West Valley Demonstration Project

SUBJECT: Report on Process Wastewater Conveyance System Integrity, West Valley  
Demonstration Project (WVDP), State Pollutant Discharge Elimination System  
No. NY-0000973

**Responses to NYSDEC Comments on Process Sewer Integrity Report**  
**NYSDEC letter dated September 25, 2002**  
**West Valley Demonstration Project (WVDP)**  
**State Pollutant Discharge Elimination System (SPDES) No. NY-0000973**  
**October 2002**

FIGURE A-1

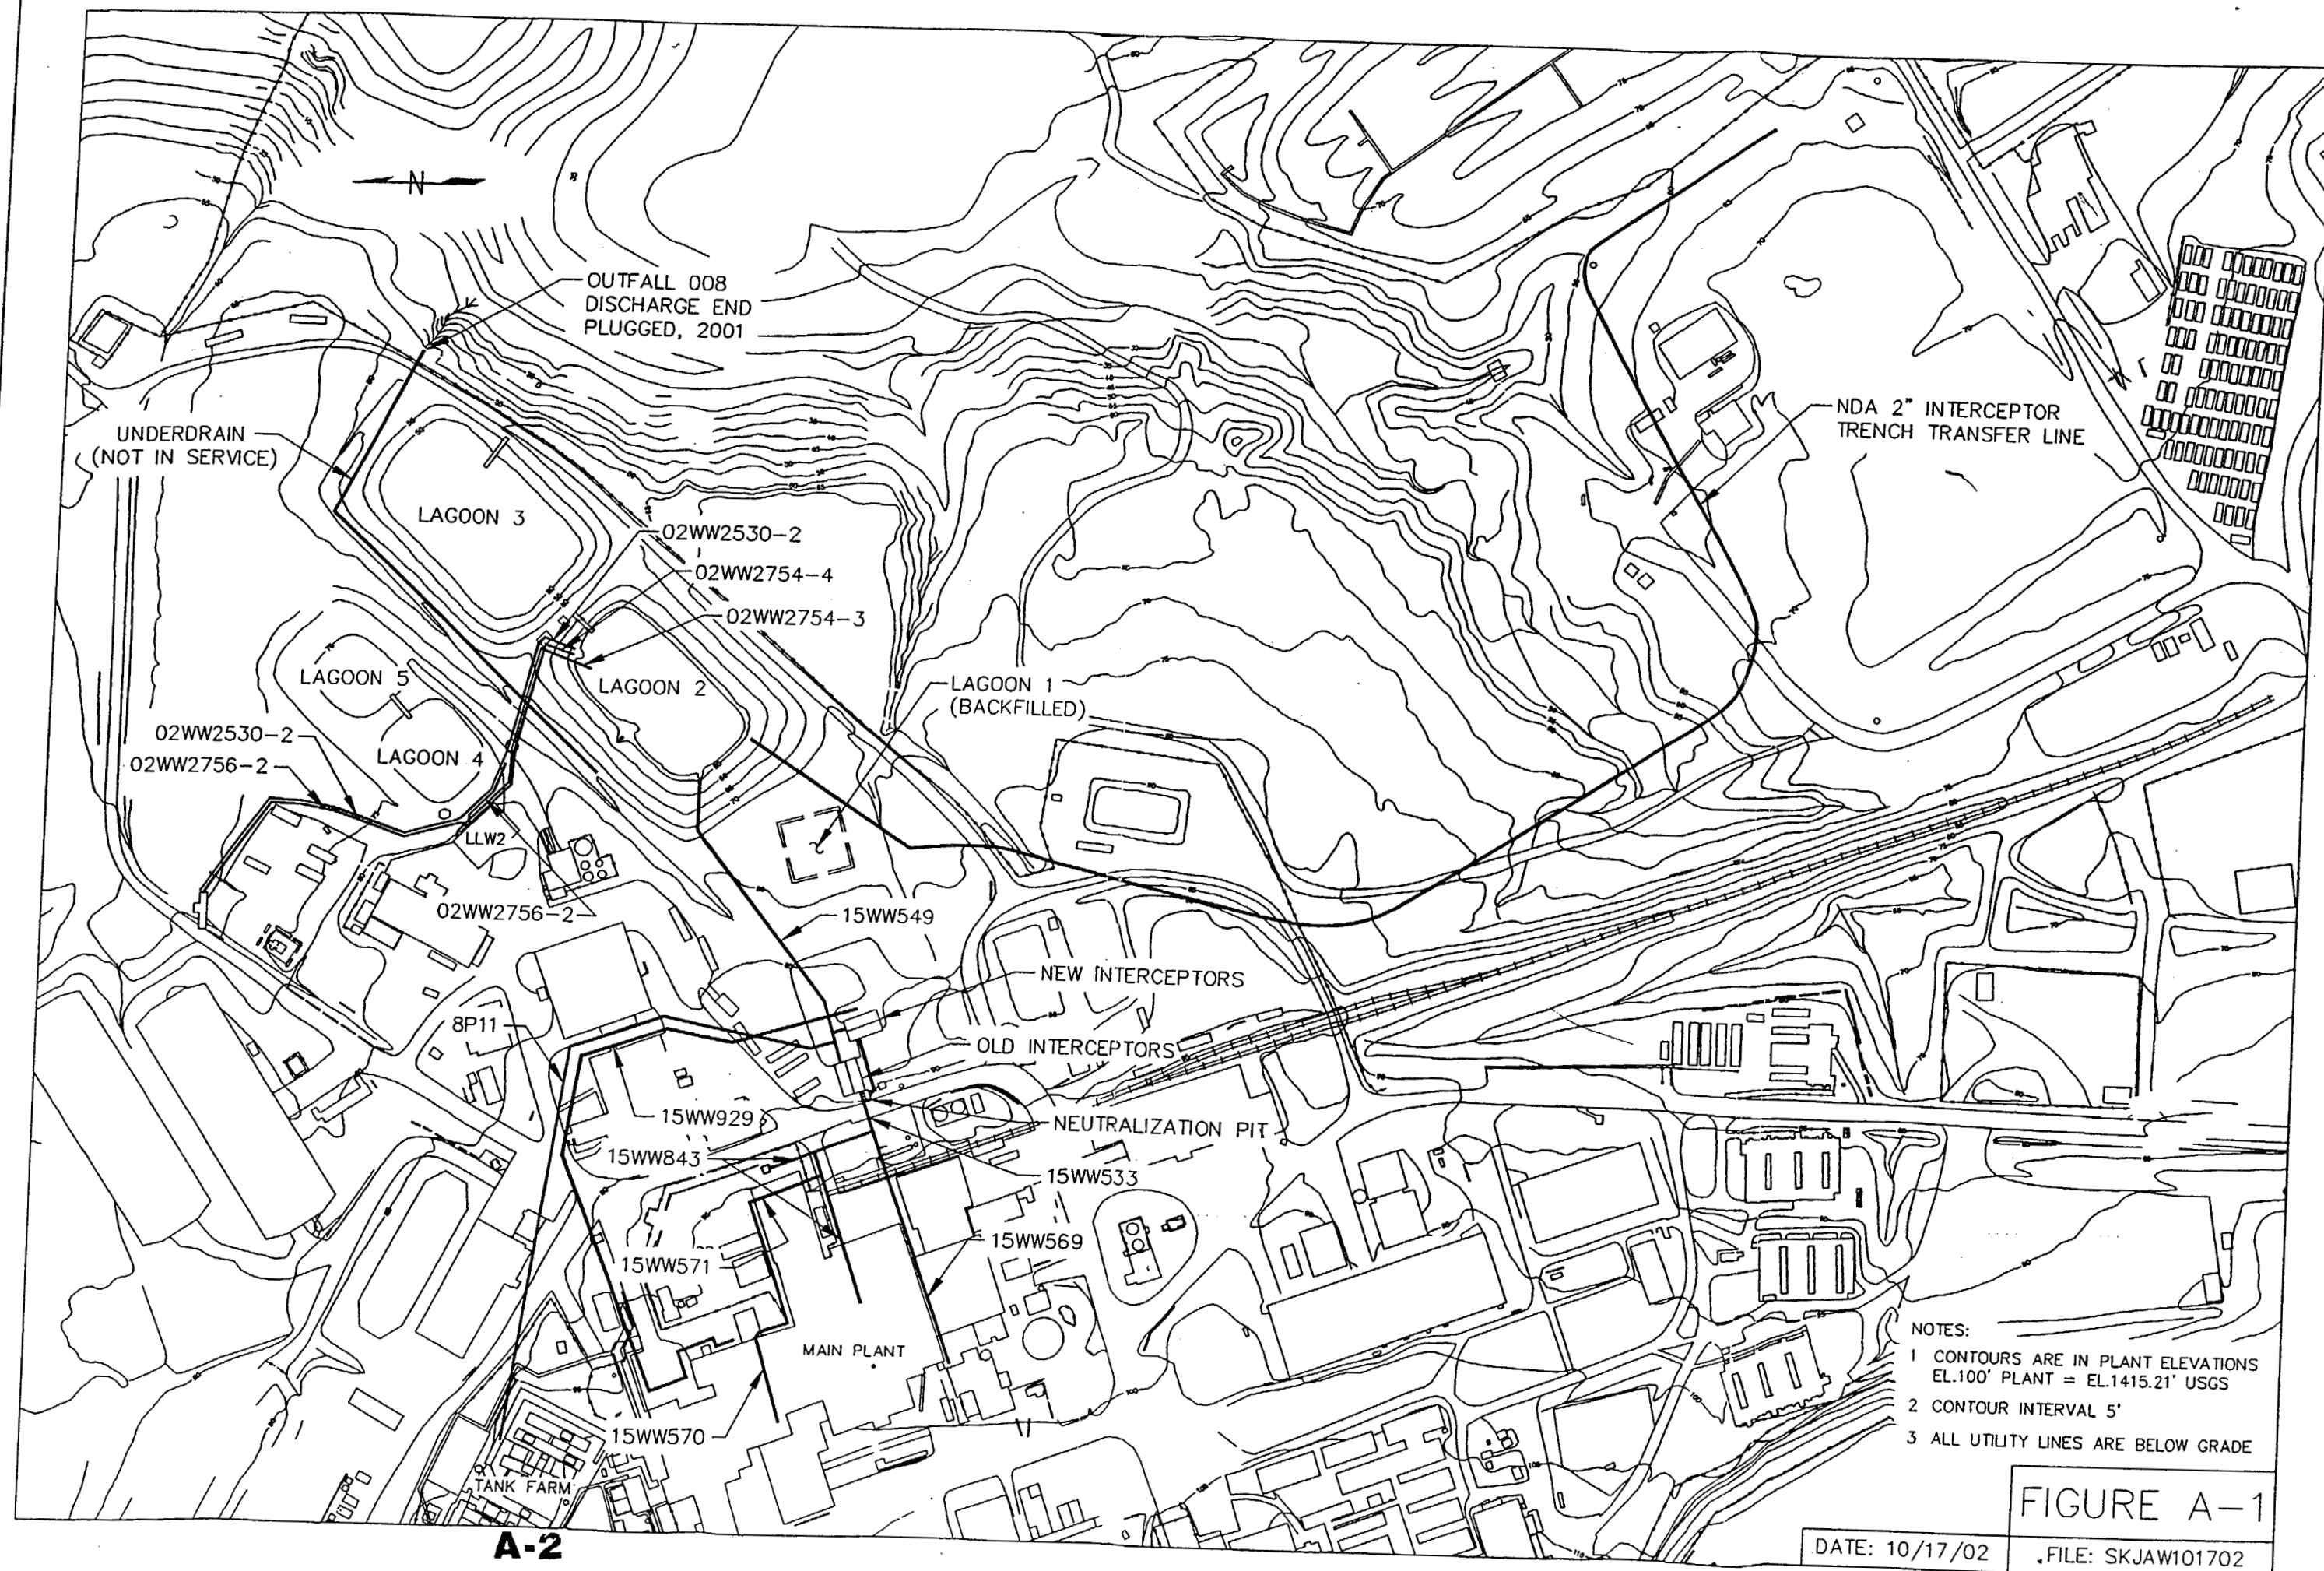
**Comment No. 1:** The location of the gravity drain (line from U.S. Nuclear Regulatory Commission (NRC) Licensed Disposal Area (NDA) to Lagoon 2) should be shown on a map. It would be helpful if the elevation of the line inverts were indicated at various points along its path.

**Comment No. 3:** The location of Lines 02-WW-2"-2756 and 02-WW-2"-2530 should be shown on a map. It isn't clear whether 02-WW-2"-2530 is above or below grade.

**Comment No. 6:** The location of lines 02-WW-3-2754 and 02-WW-4-2755 should be shown on a map.

Provided as Figure A-1 is a map showing lines with ground elevation contours. Please note that all of these are force main lines (see Enclosure 2, Errata and Corrigenda, Item No. 2 ). With respect to elevation of line inverts, precise elevations were not measured or recorded at installation. However, it is known that all of these lines are located at a minimum depth of 42 inches below grade for freeze protection purposes.

Attached is Figure A-1, which shows the location of these lines.
